FRIESLAND FOREST SUBDIVISION

APPLICATION NUMBER 7 DATE August 4, 2005
APPLICANT Friesland Forest Subdivision
REQUEST Subdivision

FRIESLAND FOREST SUBDIVISION

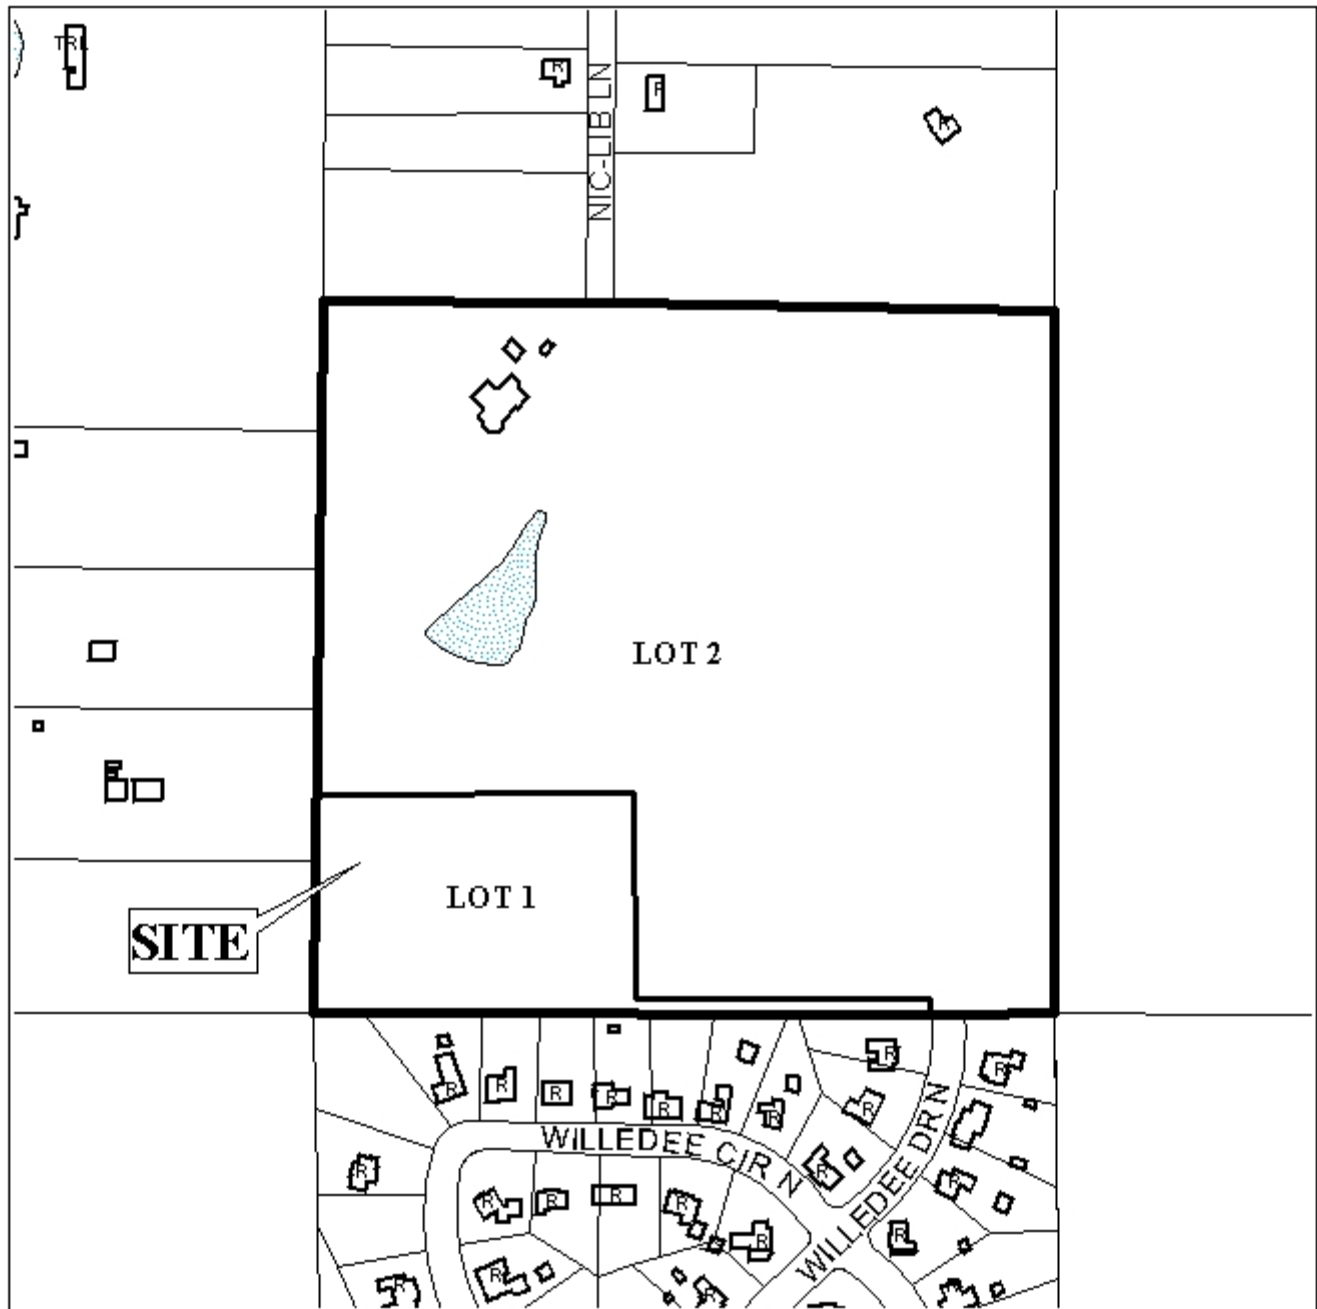
As proposed, Lot 1 would exceed the maximum width to depth ratio of the Subdivision Regulations; therefore, a waiver of Section V.D.3. would be required. Furthermore, the flag-shaped nature of Lot 1 is uncharacteristic of other properties in the area; therefore, a waiver of Section V.D.1. of the Subdivision Regulations would be required.

As proposed, Lot 1 accesses Willedee Drive North, a minor street with a 60-foot right-of-way, via dedication for the future extension of Willedee Drive North. Currently, County maintenance for Willedee Drive North terminates just South, thus there is no street frontage for Lot 1 to access. Therefore, dedication and construction of a roadway to meet County standards prior to the recording of the final plat would be necessary. Additionally, a note would be required on the final plat stating that Lot 1 could not be further subdivided.

The 25-foot minimum building setback line is not shown, but would be required on the final plat.

Based on the preceeding, this application is recommended for denial for the following reasons: 1) the proposed lot exceeds the recommended width to depth ratio identified in Section V.D.3. of the Subdivision Regulations; and 2) the flag-shaped nature of the proposed lot is uncharacteristic of other legal lots of record in the area and do not comply with Section V.D.1. of the Subdivision Regulations.
